ELITE DESIGNERS LTD
 16 ST PETERS ROAD
 TERRACE VAULTS AND
 CONSERVATORY E.A. PCMS

2022-065 SK/100 07/24 Rev A
 VISUAL INSPECTION 7/4/2024

PLANS: (Approx 1:100)
 AT GARDEN LEVEL.

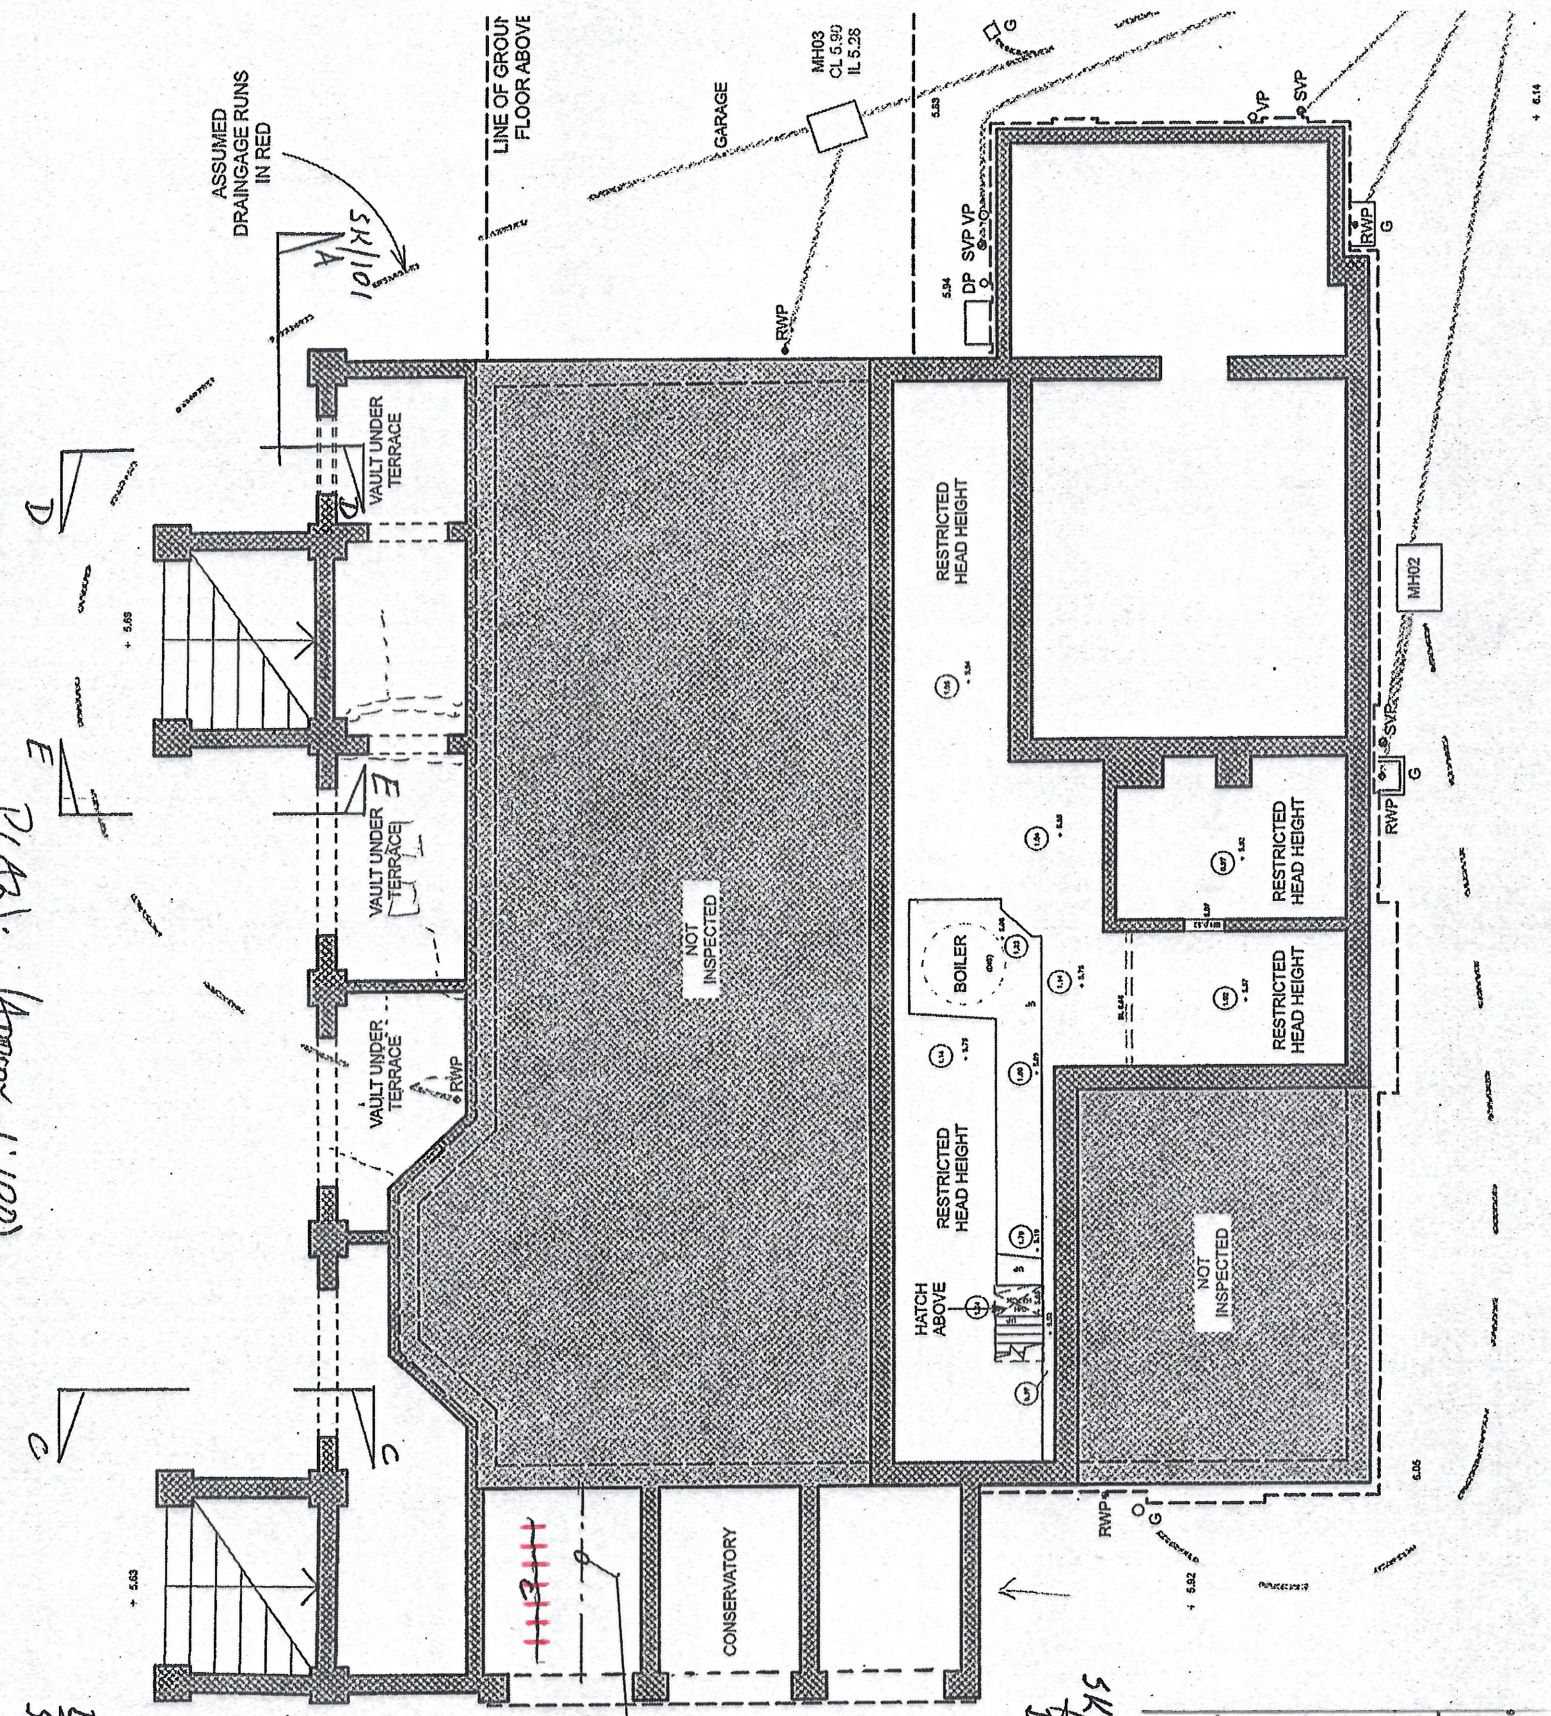
CORRODED STEEL BEAM EXPOSED
 IN UNDERSIDE OF SLAB, OVER
 PROPOSED REPAIRS TO SLAB

CRACK IN TILED FLOOR OF
 CONSERVATORY ABOVE IRREGULAR
 'CRACK' IN UNDERSIDE OF SLAB, OVER

NO 5.5 HELIBARS 400LIVE,
 AT 250% SET IN SAND-OUT
 GROOVES 40mm DEEP INTO TOP
 OF CONCRETE. CRACK ALSO
 TO BE REPAIR-INSPECTED.
 REFER TO SK/200 FOR
 SCHEDULE OF PROPOSED REPAIRS.
